Washington Public Power Supply System

Docket No. 50-508
April 27, 1984
G03-84-265

Subject: NUCLEAR PROJECT 3
RESPONSES TO NRC QUESTIONS

This transmittal includes responses for 20 Questions from the NRC's Power Systems Branch pertaining to the WNP-3 Emergency Diesel Generators. The Supply System had not previously scheduled these responses for transmittal for NRC review per reference a).

FIGURE 9.5.4.1

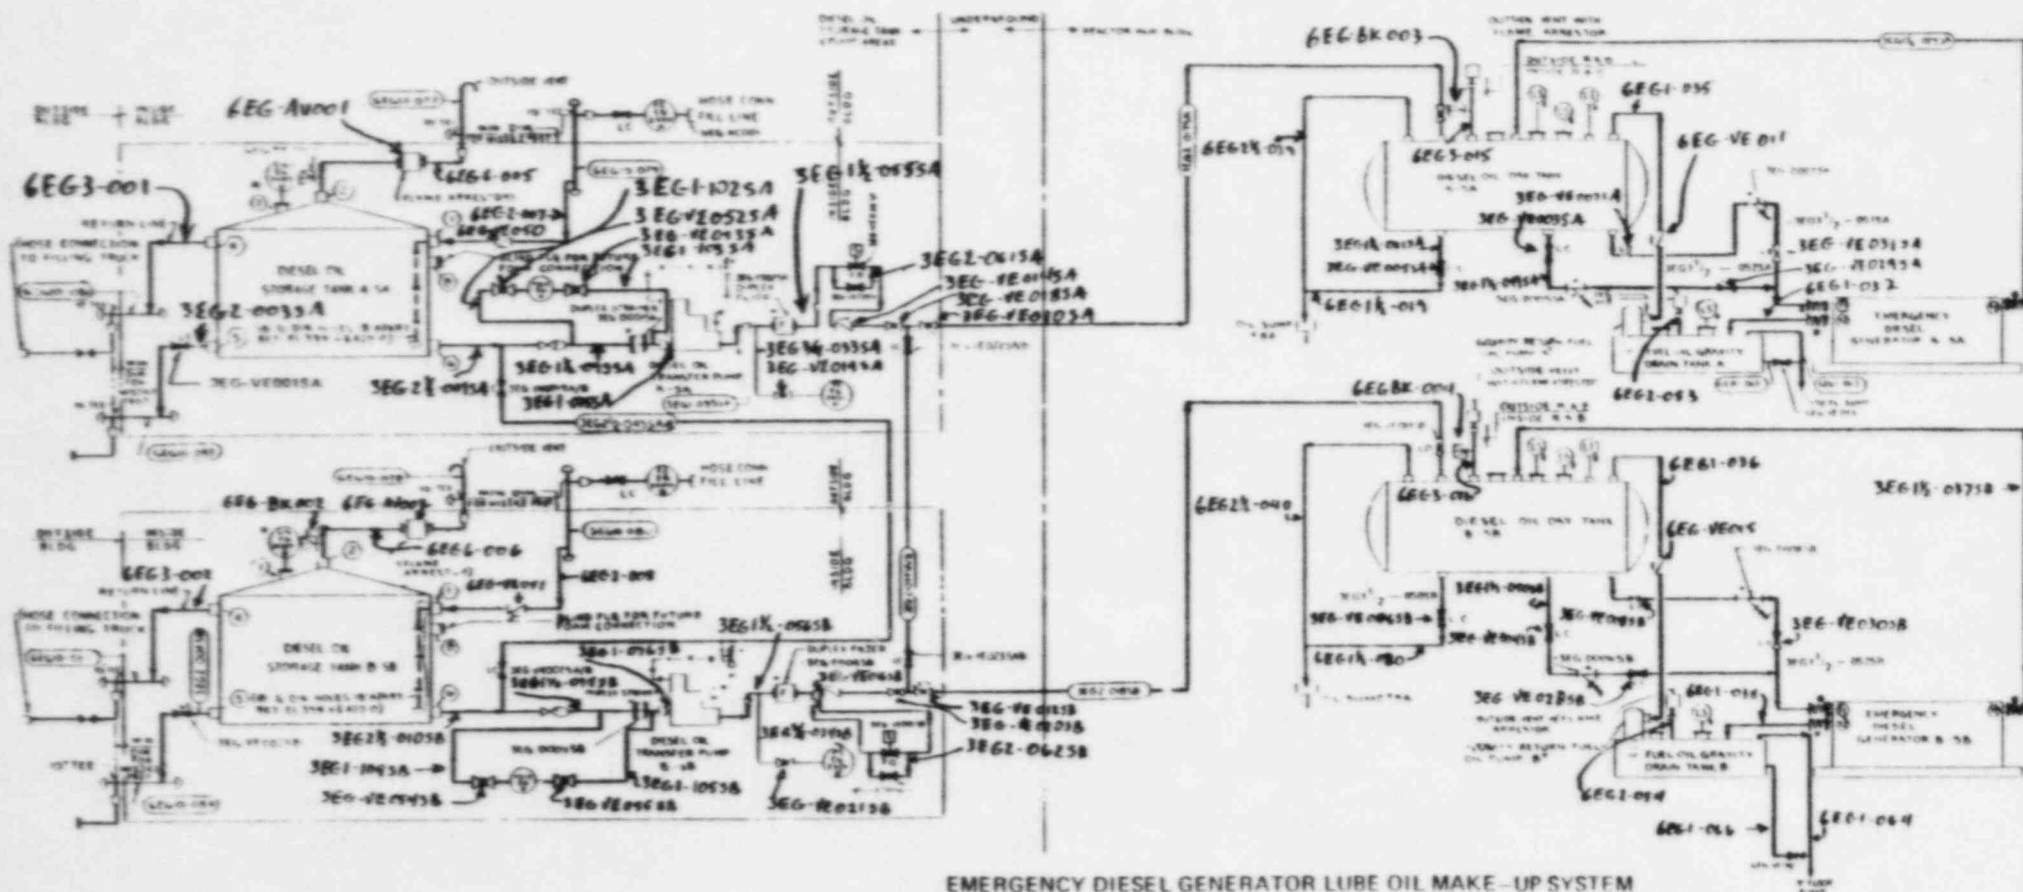
430.11 The FSAR does not adequately address piping classification in the
(SRP fuel oil storage and transfer system. Revise the FSAR (Section
9.5.4) 9.5.4.2.4) to state what piping conforms to ASME Section III, and
 what piping conforms to ANSI B31.1. Indicate piping
 classifications on Fig. 9.5.4-1, and identify all interfaces where
 there is a change of classification.

Section 9.5.4.2.4 and Figure 9.5.4-1 will be revised as shown to more clearly indicate the piping design classifications.

The diesel fuel oil storage tanks and day tanks are designed in accordance with ASME III Class 3 requirements. The diesel fuel oil gravity drain tanks are designed to ANSI B31.1 requirements since they are not essential for the operation of the diesel. The diesel fuel oil gravity drain tanks are, however, seismically analyzed.

All essential pressure retaining portions of the diesel fuel oil storage and transfer systems are designed to ASME Section III Class III requirements as shown in Figure 9.5.4-1.

The piping connected to the diesel fuel oil gravity drain tanks are designed to ANSI B31.1 requirements as are all nonessential portions of the diesel fuel storage and transfer system shown in Figure 9.5.4-1. These nonessential portions of the diesel fuel oil transfer system are however seismically supported.

WASHINGTON PUBLIC POWER SUPPLY SYSTEM Nuclear Projects 3 & 5 FINAL SAFETY ANALYSIS REPORT
INTERCOOLER & INJECTION COOLING SYSTEM
FIGURE 9.5.5-2

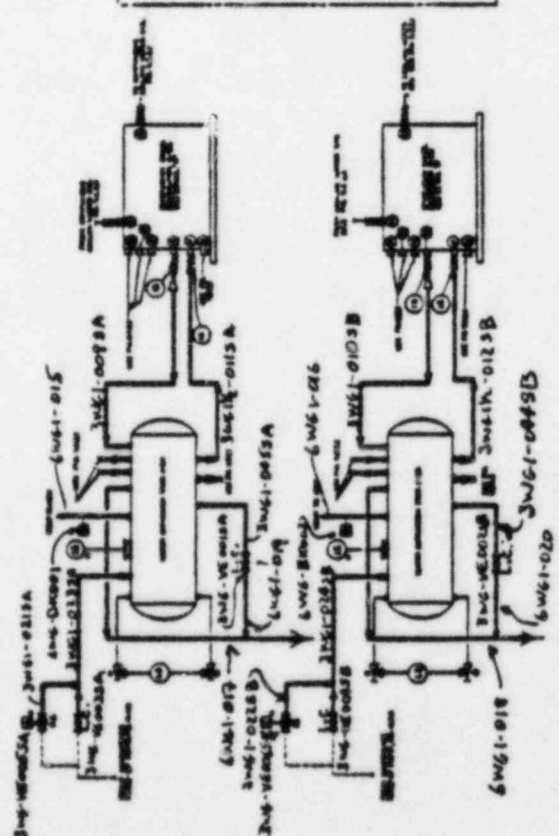
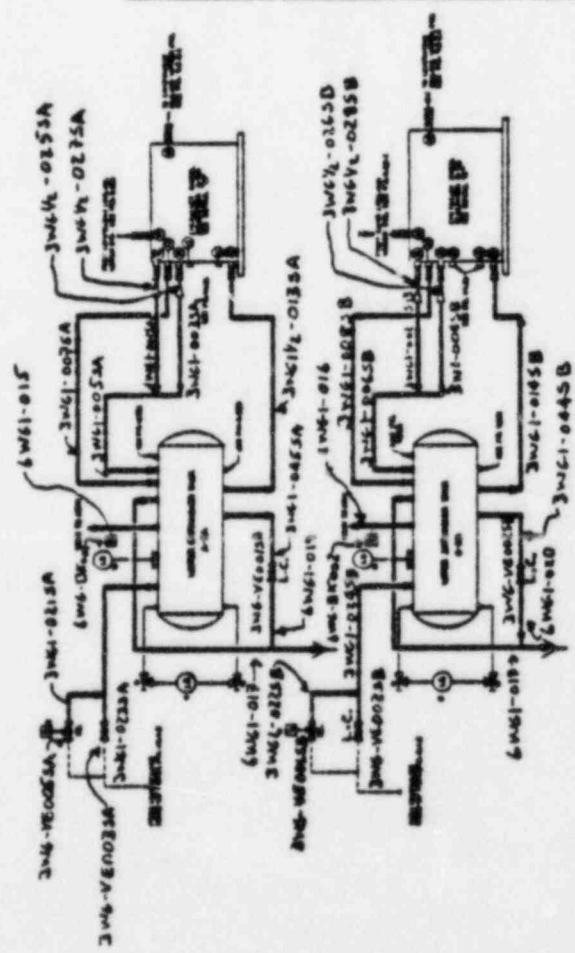
430.30 (SRP 9.5.5) Refer to FSAR Fig. 9.5.5-1 and 9.5.5-2. On 9.5.5-1, you show the expansion tank piping from the engine jacket water system to the engine skid boundary as non-ASME Section III. On the same figure, you also show the engine keep warm piping, between the normally open plug valves, as non-ASME Section III. This is not acceptable. We require all cooling water system piping, from the diesel engine interface out, to be ASME Section III, Class 3. Revise your design accordingly, or provide justification for noncomformance.

On both 9.5.5-1 and 9.5.5-2, you do not provide a classification for piping between the diesel engine skid and the expansion tank. We require that this piping also be ASME Section III, Class 3. Confirm that this piping meets this requirement, and revise FSAR Figs. 9.5.5-1 and 9.5.5-2 to show the piping classification. Also, provide a legend for the piping, valves, indication and instrumentation associated with the expansion tanks.

The piping between the jacket water expansion tank to the diesel generator skid interface points is designed to ASME III Class 3 requirements. FSAR Figure 9.5.5-1 and 9.5.5-2 will be revised to more clearly depict this.

WASHINGTON PUBLIC POWER SUPPLY SYSTEM
Nuclear Projects 3 & 5
FINAL SAFETY ANALYSIS REPORT
EMERGENCY DIESEL GENERATOR
AIR INTAKE & EXHAUST SYSTEM
FIGURE 9.5.8-1

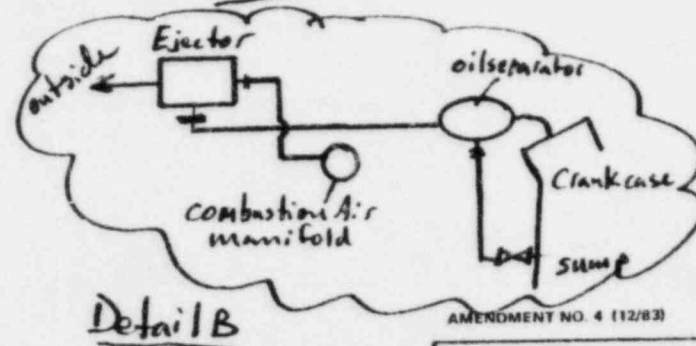
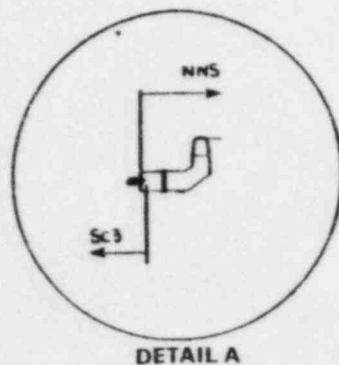
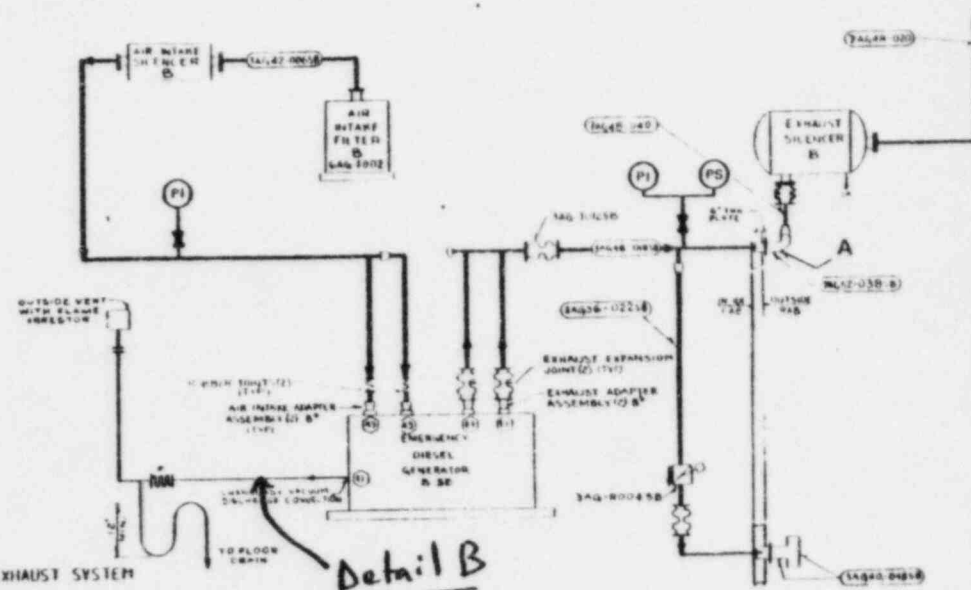
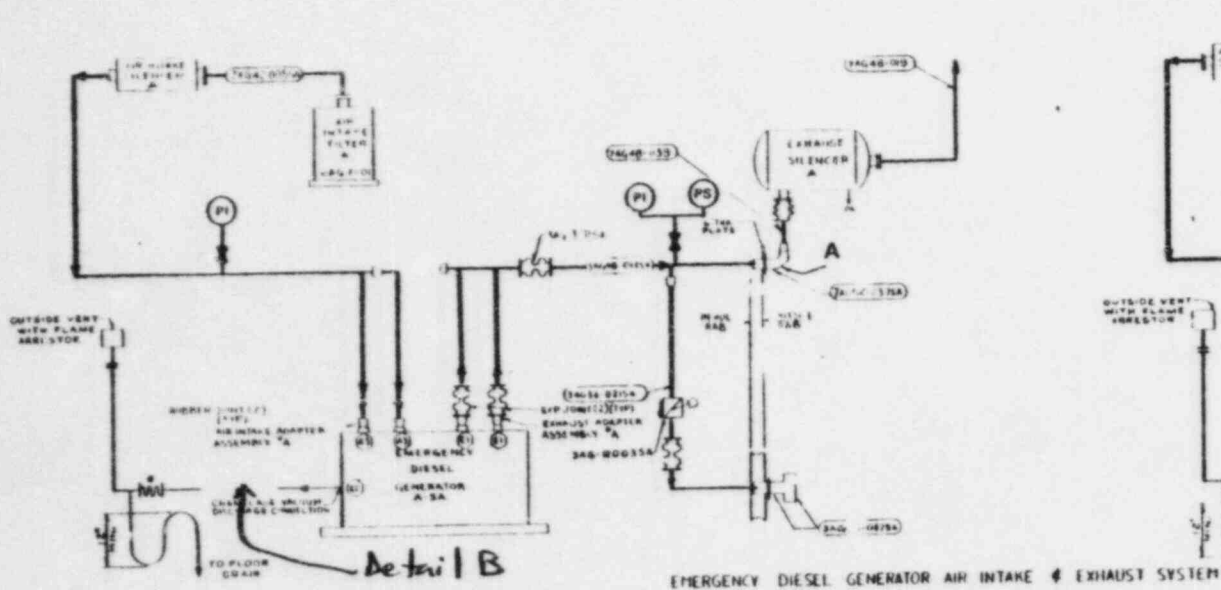
430.43 In the FSAR, you briefly discuss a crankcase evacuation system.
(SRP 9.5.7) Expand your FSAR to provide a diagram and additional descriptive information on this system as follows: 1) what components make up the evacuation system, 2) what is the source of power for the evacuation system, 3) where are crankcase gases discharged, and 4) does the evacuation system operate on the rocker lube system reservoir.

The terms crankcase evacuation system and crankcase vacuum system are used synonymously. It is desirable to maintain the crankcase under a slight vacuum (1 to 2" H₂O) in order to cause a slight flow of air into the crankcase at seals, such as at the crankshaft seal, crankcase covers, etc. Without this, there would be a slight pressure inside the crankcase due to normal piston ring blowby, and lube oil and vapor would tend to leak from the seals and gasketed areas. The slight vacuum minimizes outward weepage and results in a cleaner engine.

This system is not essential for the operation of the diesel. FSAR Figure 9.5.8-1 will be revised to reflect the response to this question.
